ADDENDUM NO. 1

March 17, 2022

STR Project Number 21051.01

Project:
D116 RLHS Theater AV Improvements
Round Lake High School
Round Lake High School Drive
Round Lake, Illinois 60073

DRAWING TITLE
AV DEMOLITION PLAN

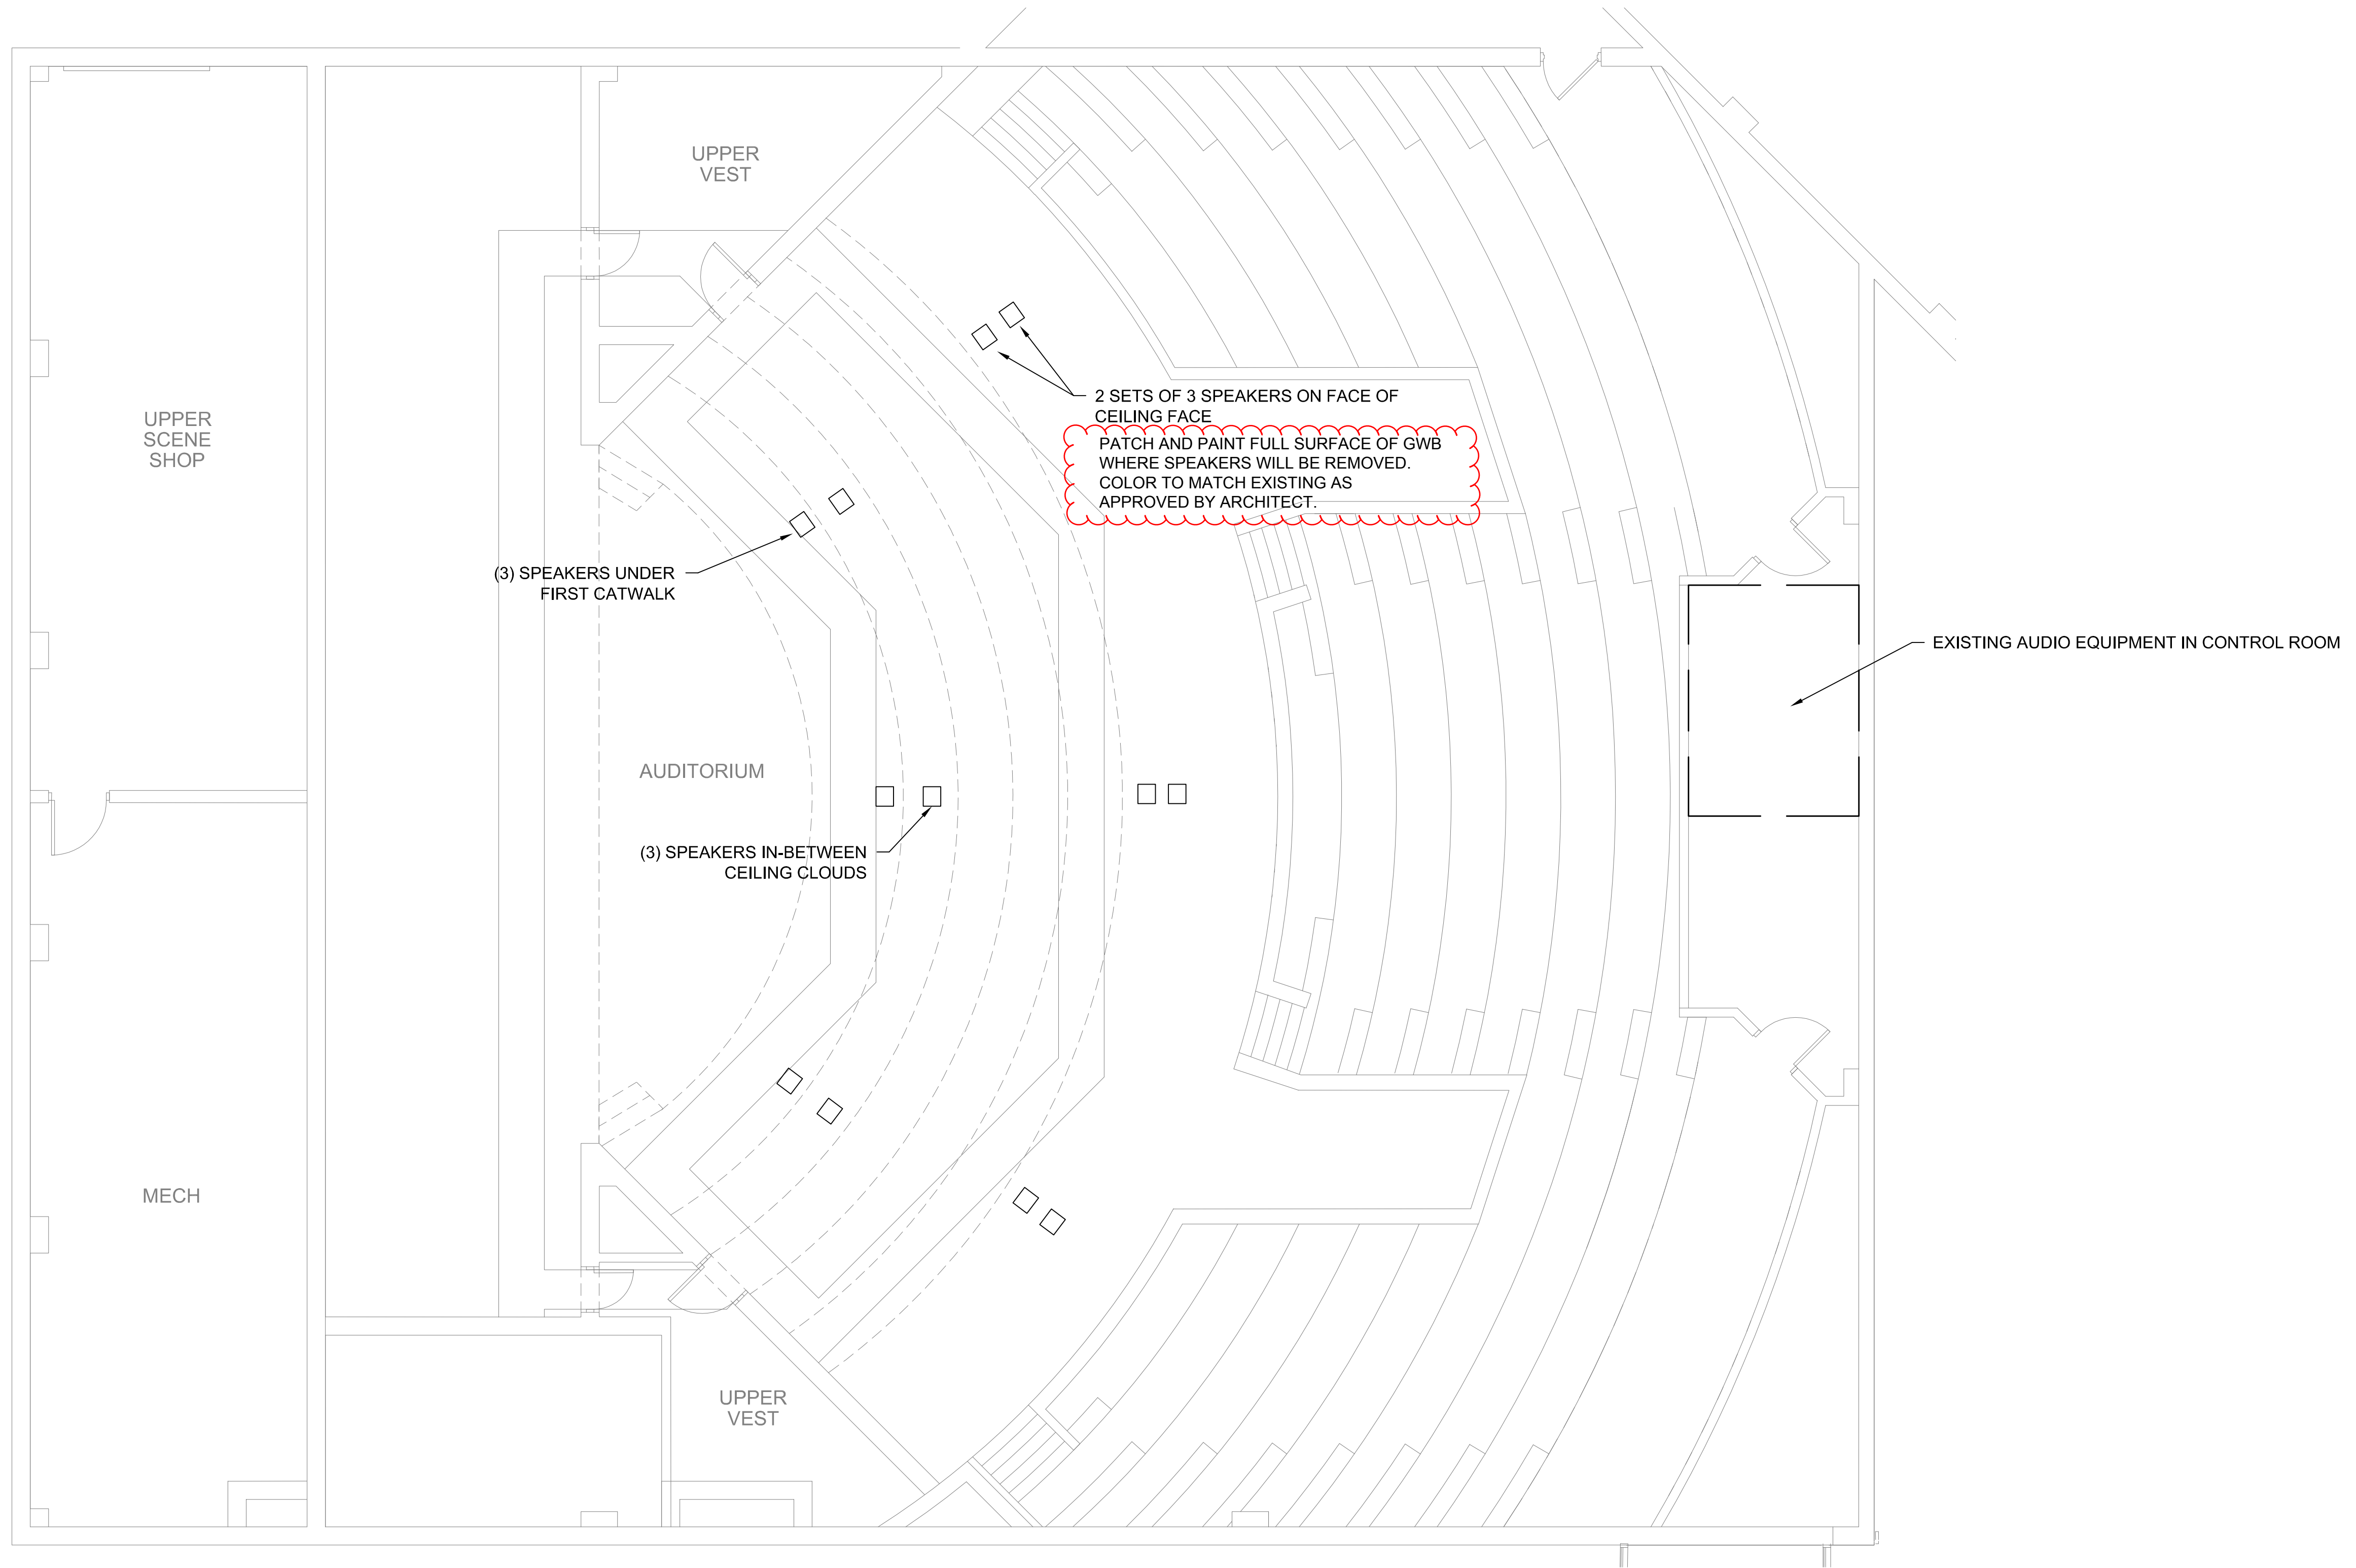
1. **Sheet AV-01, AV DEMOLITION PLAN**
 - a. **CLARIFY** - Added note.
2. **Sheet AV-02, AV LAYOUT- AUDITORIUM MAIN LEVEL**
 - a. **CLARIFY** - Added note.
3. **Sheet AV-03, AV LAYOUT- AUDITORIUM MEZZANINE LEVEL**
 - a. **CLARIFY** - Added note.

2 SETS OF 3 SPEAKERS ON FACE OF
 CEILING FACE
 PATCH AND PAINT FULL SURFACE OF GWB
 WHERE SPEAKERS WILL BE REMOVED.
 COLOR TO MATCH EXISTING AS
 APPROVED BY ARCHITECT.

NOTE:
 AT AREAS WHERE EQUIPMENT, RIGGING, AND WIRING HAS BEEN REMOVED, THE EXISTING FINISH SHALL BE PATCHED, REPAIRED AND REFINISHED TO MATCH EXISTING. CONFIRM WITH ARCHITECT FINISH.

1 LOWER LEVEL - ELECTRICAL PLAN

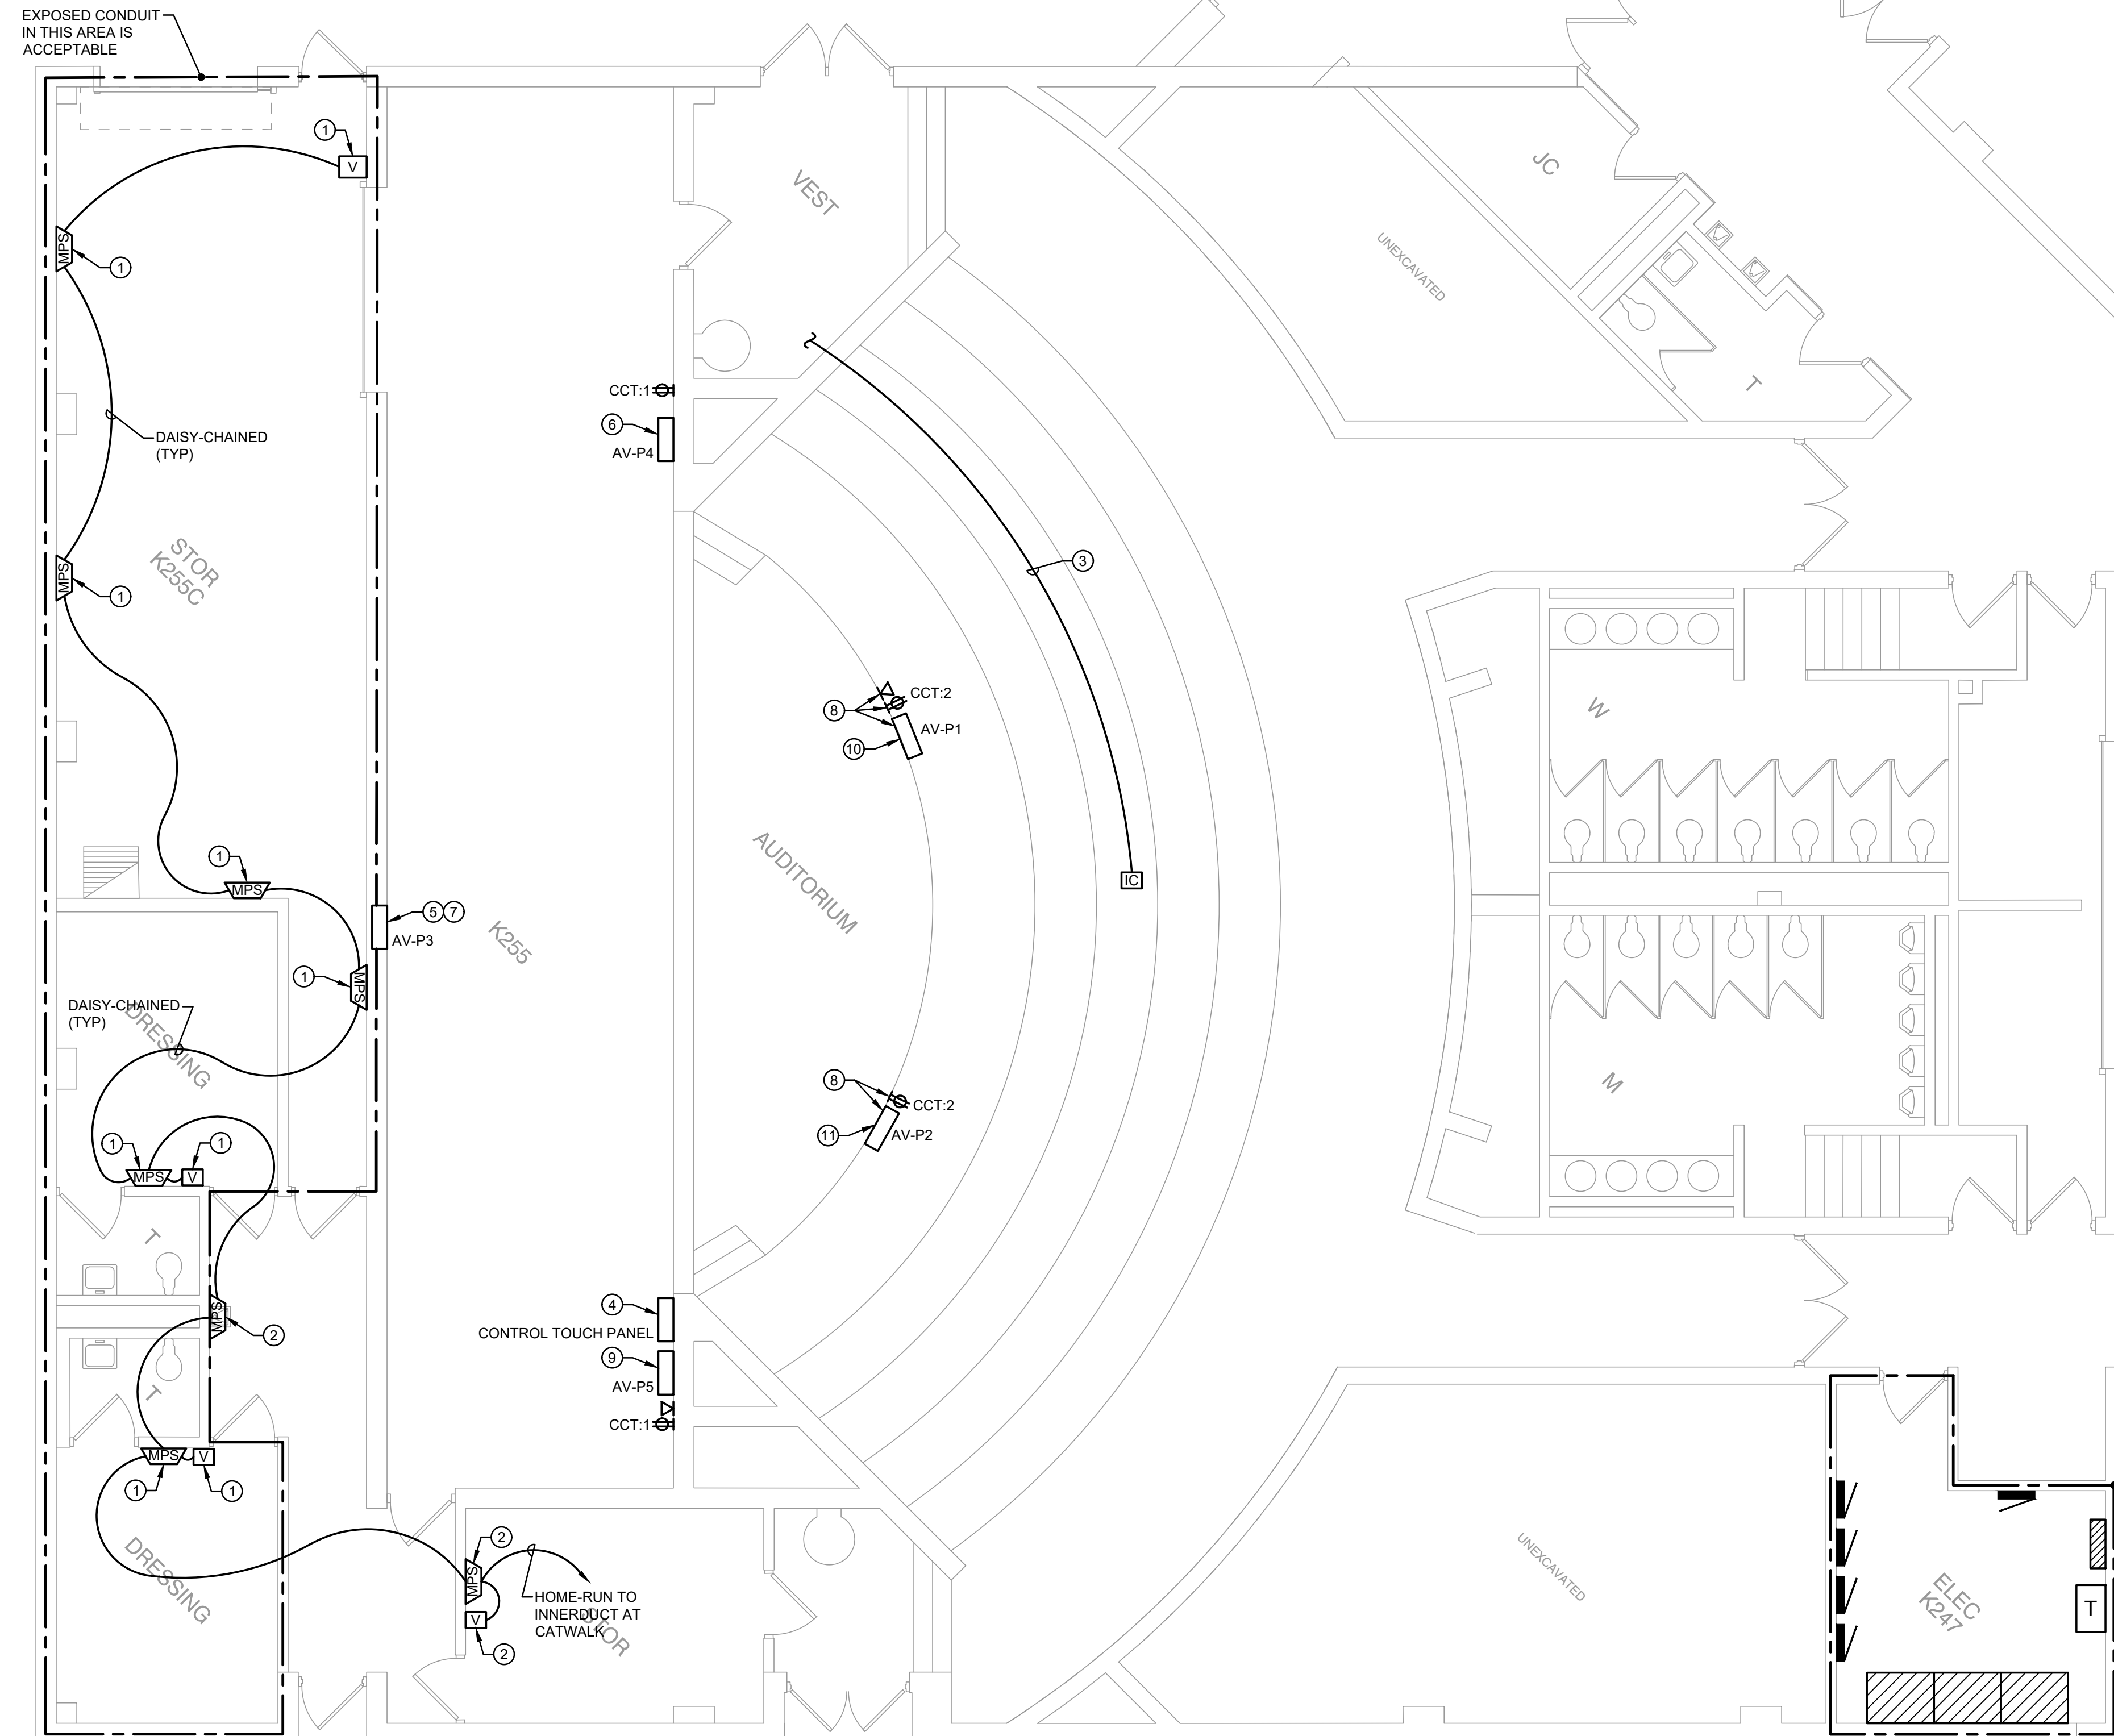
1. **Sheet E1.0, LOWER LEVEL - ELECTRICAL PLAN**
 - a. **CLARIFY** - Revised and added notes.
2. **Sheet E1.1, UPPER LEVEL - ELECTRICAL PLAN**
 - a. **CLARIFY** - Revised and added notes.
3. **Sheet E1.2, UPPER LEVEL - ELECTRICAL PLAN**
 - a. **CLARIFY** - Revised and added notes.

ALL EXPOSED CONDUITS IN THEATER AREA (WITH BLACK WALLS) SHALL BE PAINTED BLACK. ALL EXPOSED CONDUITS IN THEATER AND STAGE AREA SHALL BE COLOR AS APPROVED BY ARCHITECT.

WHERE EQUIPMENT, CONTROLS, AND WIRING ARE INSTALLED THE ADJACENT FINISH SHALL BE PATCHED, REPAIRED AND FINISHED TO MATCH EXISTING.

CONTRACTOR SHALL HOMERUN NEW BRANCH CIRCUITS TO AVAILABLE PANEL SPACES WITHIN THIS ROOM. FIELD VERIFY AVAILABILITY PRIOR TO ROUGH-IN.
